HISTORIC AND DESIGN REVIEW COMMISSION

March 20, 2019

HDRC CASE NO: 2019-043
ADDRESS: 224 E CAROLINA ST
LEGAL DESCRIPTION: NCB 2956 BLK LOT B
ZONING: RM-4, H
CITY COUNCIL DIST.: 1
DISTRICT: Lavaca Historic District
APPLICANT: Peter Matthew Price
OWNER: Peter Matthew Price
TYPE OF WORK: Amend previous approval for porch and addition; Tax Certification
APPLICATION RECEIVED: January 10, 2019
60-DAY REVIEW: March 09, 2019
REQUEST:

The applicant is requesting a Certificate of Appropriateness for approval to:

EXISTING ELEVATIONS

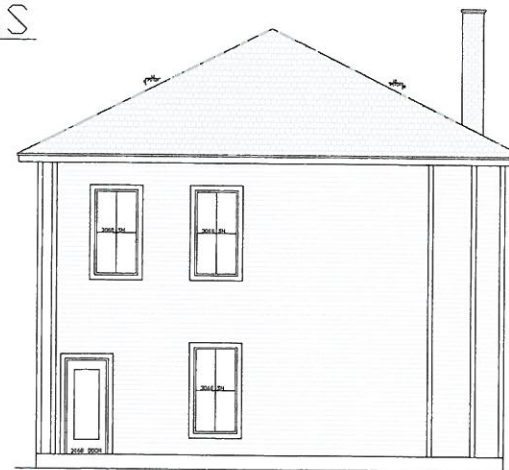
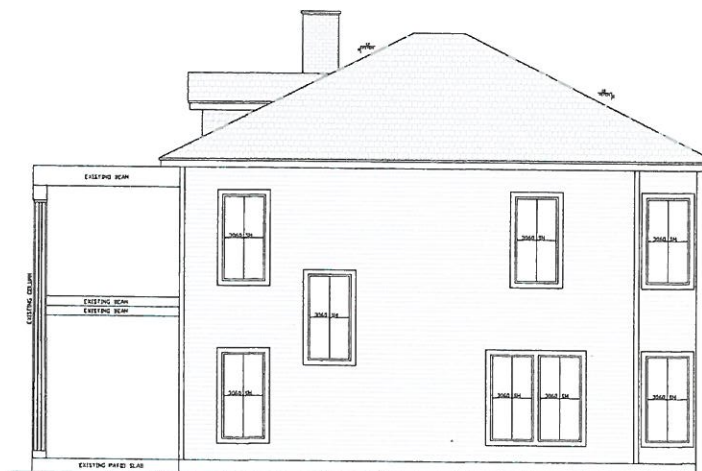
- d. ADDITION – The applicant is requesting to replace the existing rear portion of the house which featured an inset side elevation and 5 wood sashed windows and a rear door with a larger rear addition that is flush to the side elevations of the primary structure and includes a rear door, a set of double-doors, 1 sashed window, and 1 square picture window. Staff finds that the rear portion was constructed during the period of significance of the property as depicted in the 1911 Sanborn map and should be preserved in-place including its windows. Staff finds that the proposed modification inconsistent with the following Guidelines:

- i. Complies with reconstruction design from the 2016 HDRC approval to feature full-height classical columns.
- ii. Restore the rear portion to its original configuration after submitting plans to staff – or resubmit a plan for a rear addition that includes appropriate fenestration and inset side wall planes.
